METROPOLITAN GOVERNMENT OF NASHVILLE AND DAVIDSON COUNTY

STAFF RECOMMENDATION

1706 Ordway Place

Application: New construction - addition

Figure 1. 1706 Ordway Place

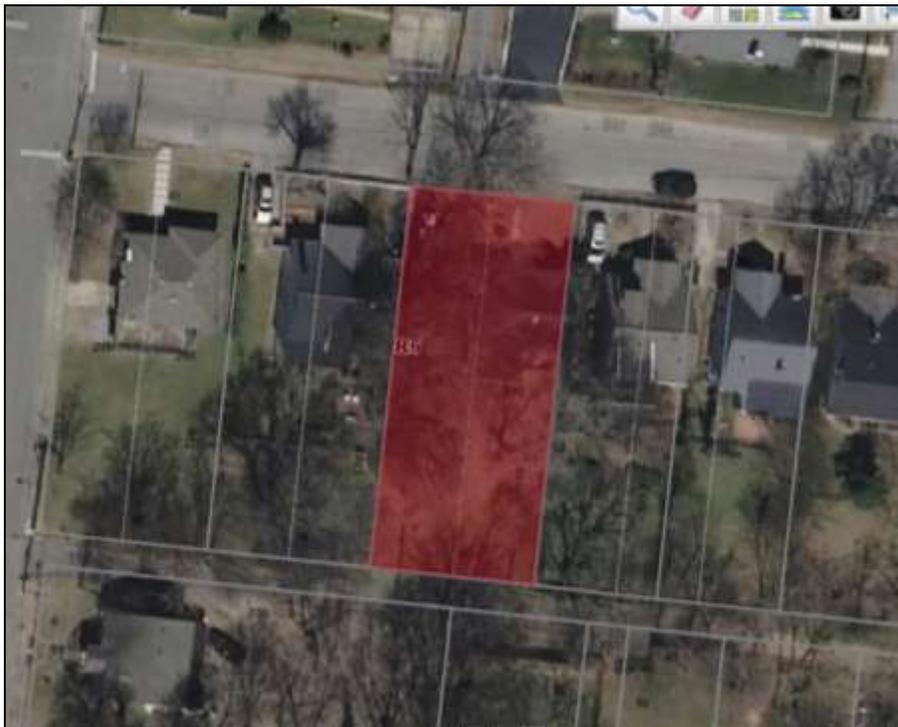
Background: 1706 Ordway Place dates to 1925 and is a contributing building in the Lockeland Springs-East End Neighborhood Conservation Zoning Overlay.

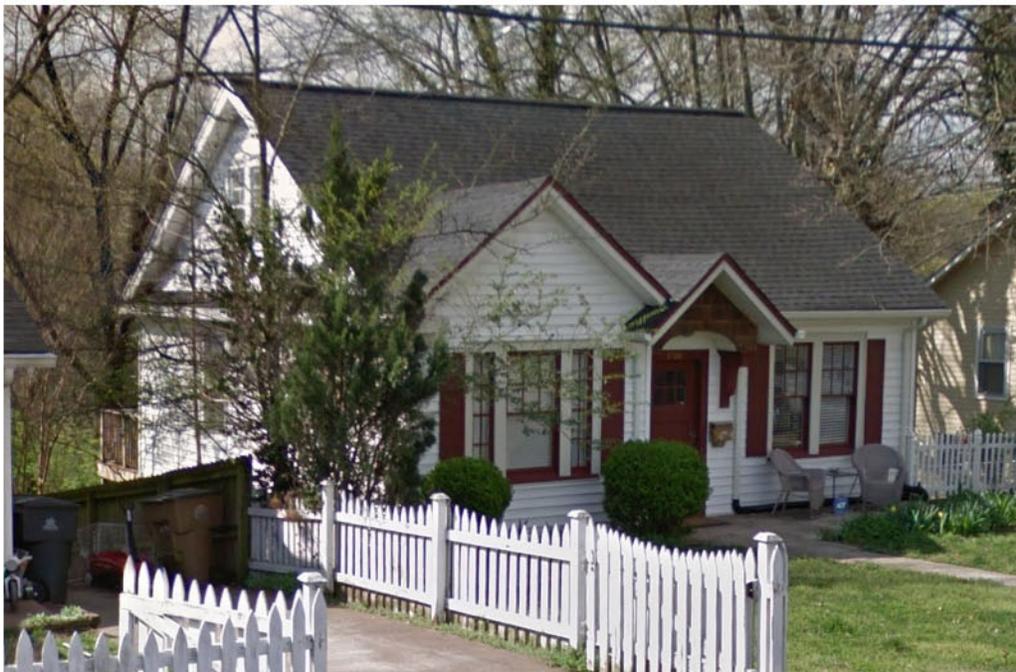
Proportion and Rhythm of Openings: The application does not indicate any changes to the window and door openings on the existing house. The windows on the addition are generally twice as tall as they are wide, meeting the proportion of historic window openings. There are no large expanses of wall space without a window or door opening. Staff finds the project’s proportion and rhythm of openings to meet Section II.B.1.g and II.B.10.e.

LEFT ELEVATION 1/8" = 1'

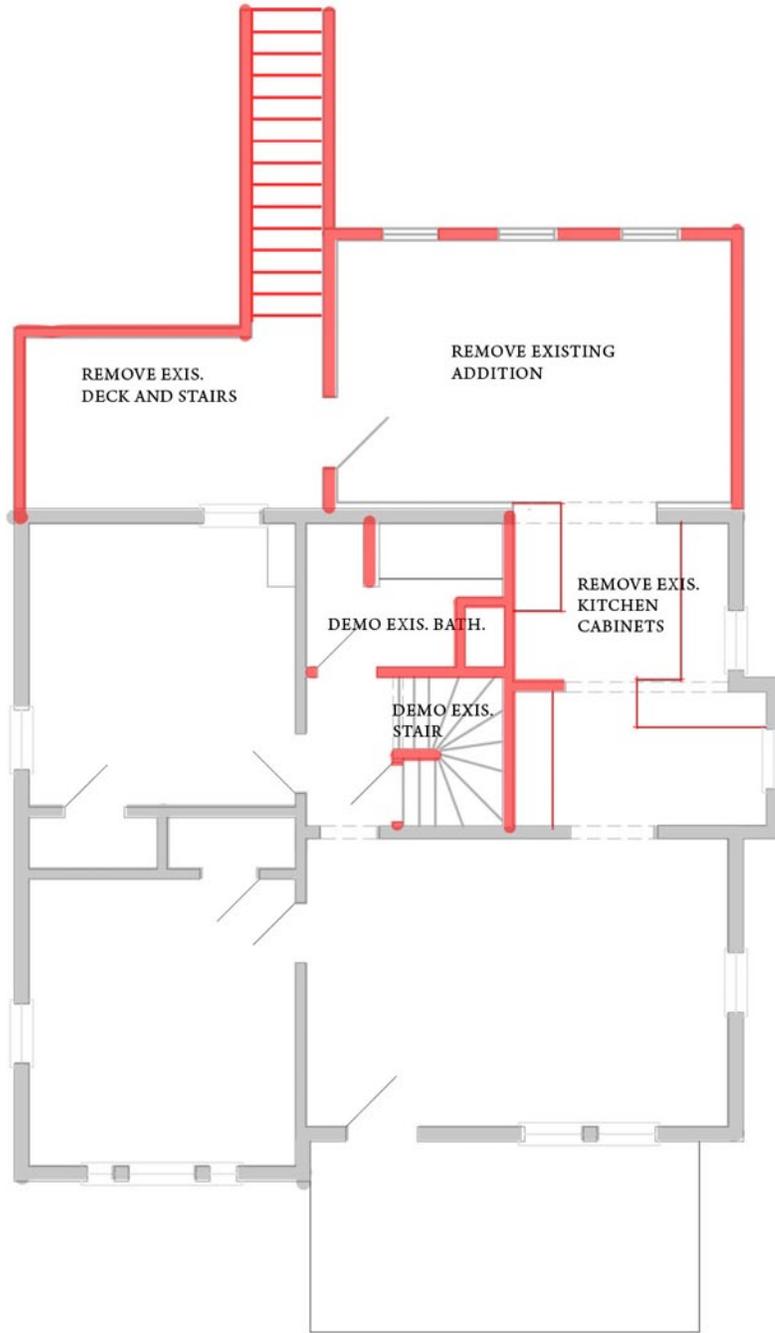
Roof form: The addition features gabled roofs in an ell form with 9/12 pitch. A shed dormer on the left side has 2/12 pitch. The rear porch roof is also gabled, with 4/12 pitch. These roof forms and pitches are found in the district and are compatible with nearby roofs. The project meets section II.B.1.e and II.B.10.e.

JEZEWSKI RESIDENCE 1.27.17
 MAIN FLOOR 1/8" = 1'
 640 S.F. +/- NEW CONSTRUCTION
 FOUR SQUARE DESIGN STUDIO

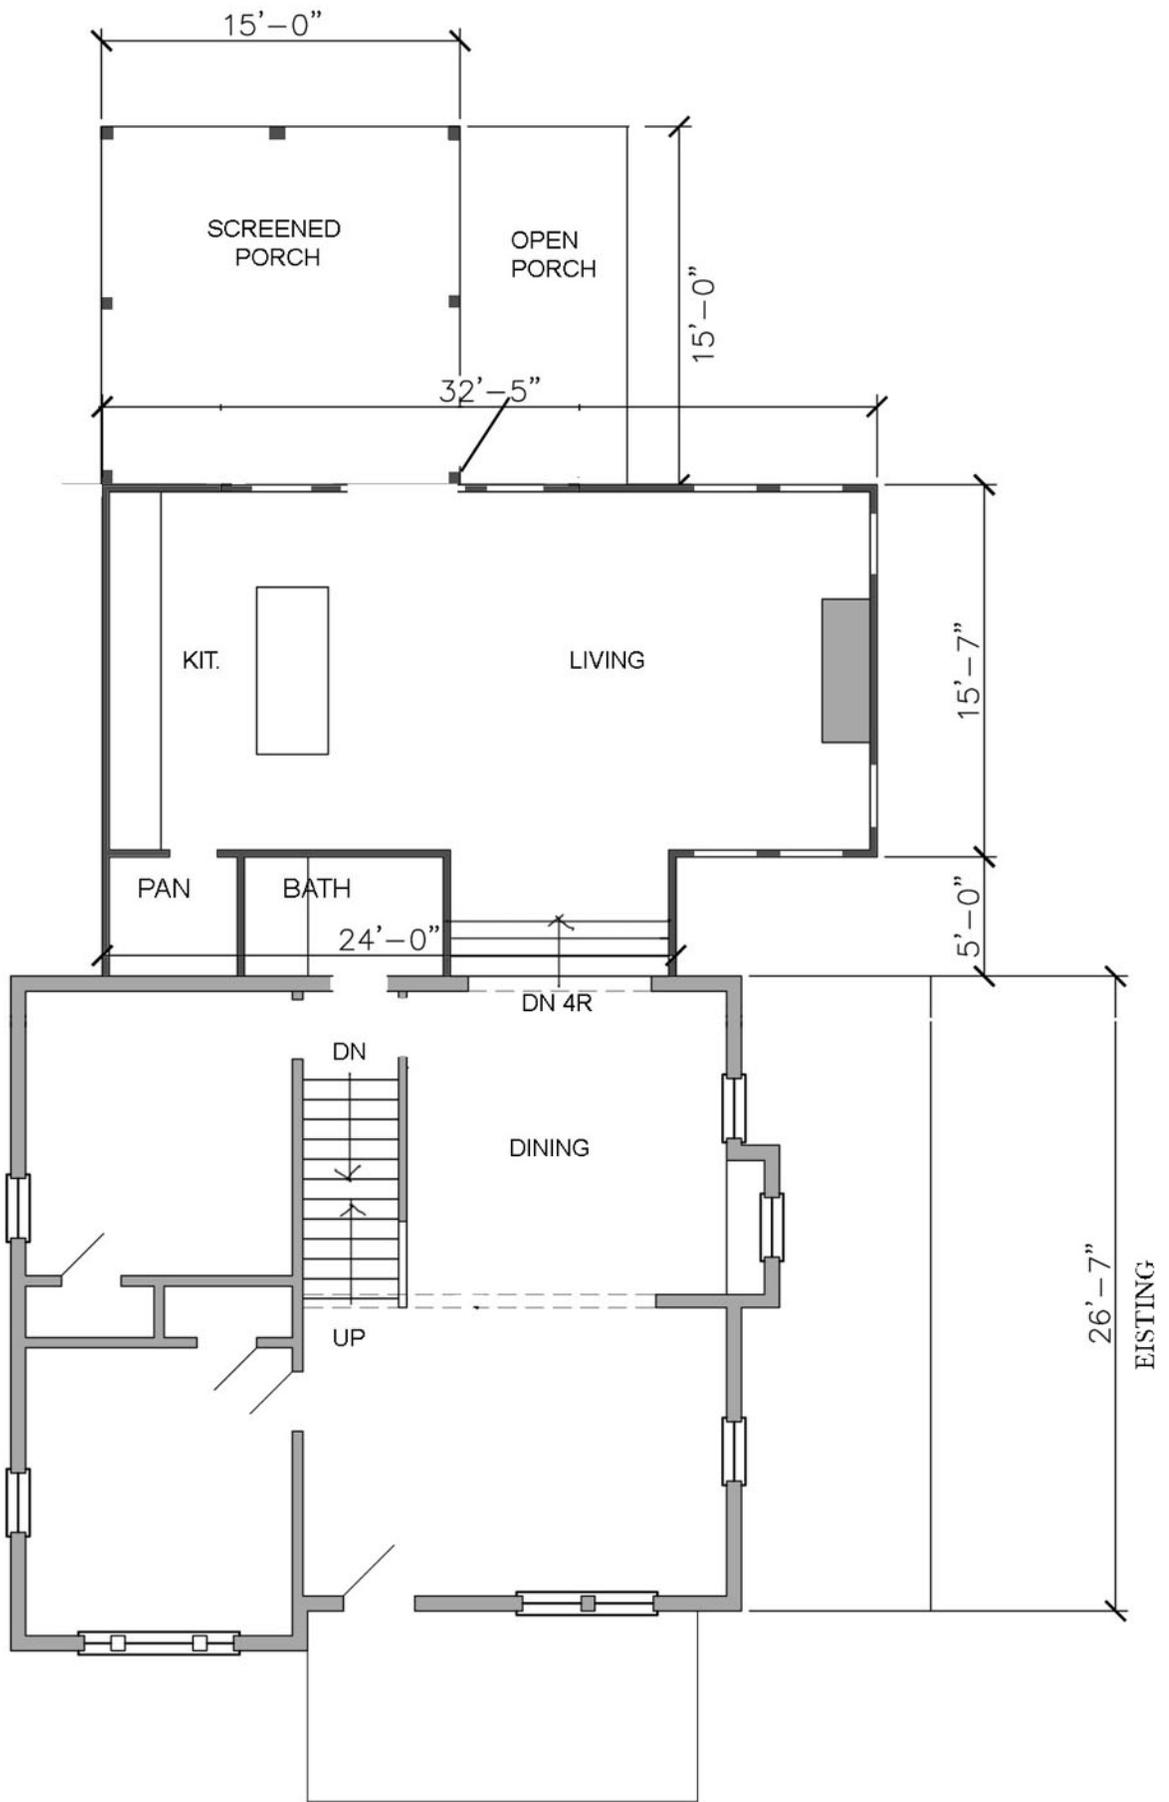
The main part of the addition’s living space is six feet (6’) wider than the house on its right side. The design guidelines specify that an addition may be permitted wider than the house when the existing building is narrower than thirty feet (30’) or is shifted to one side of the lot. In this case, the existing building is thirty feet (30’) wide, and is shifted to the left side of the lot. Staff finds that the wider addition is appropriate in this instance. The project meets sections II.B.10.a and b for additions.

Design, Location & Removability: The addition is located at the rear of the historic building, in accordance with the design guidelines for additions. It is inset from the rear corners of the house by four feet (4’) and three feet (3’) from the left and right sides, respectively. Due to the insets, different materials, and complimentary roof form, if the addition were to be removed in the future, the primary form of the house would remain. Staff finds the design, location and removability are appropriate, and the project meets sections II.B.10.a, d and e.
